AGENDA MEMORANDUM

Title: Resolution: Approving a Site Development Plan for the Proposed Lot 1, Block 4, Promenade at Castle Rock, Filing No. 1

Proposed Site Development Plan

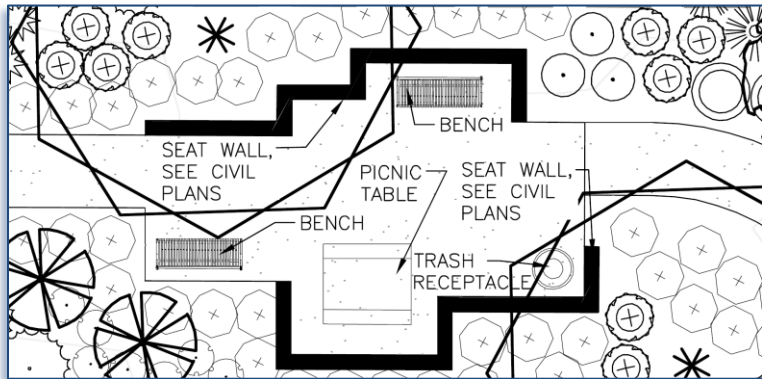
Staff has completed the final review of the proposed Site Development Plan. The applicant is in the process of making revisions to the SDP that address and resolve the staff comments. At the writing of this report the revised SDP submittal has not been received, therefore, the outstanding items are outlined below and grouped by subject. A recommendation of approval should be conditioned upon resolution of the outstanding items and the motion below is written to that effect.

- Correct the SFE total for the development to 20 SFE plus the SFE for the irrigation taps.
- Add the recording date and reception number of the Promenade at Castle Rock Development Agreement.
- Submit an updated SDP reflecting appropriate roundabout access modifications.
- Master Developer obtains CDOT Access Permit for connection to Castle Rock Parkway prior to issuing an infrastructure Construction Permit for this site.

The only comment that has the potential to affect the above ground improvements proposed with this SDP is related to the roundabout access modifications. If, for example, modifications to the roundabout necessitate the addition of a lane on the primary access drive to the site, the sidewalk, landscaping and/or the fueling station may shift. The applicant and staff are continuing to work through the remaining comments and an update will be provided to the Commission at the hearing regarding the items that have been resolved. Staff concludes that any or all of these potential changes would have little effect on the major attributes of the site design.
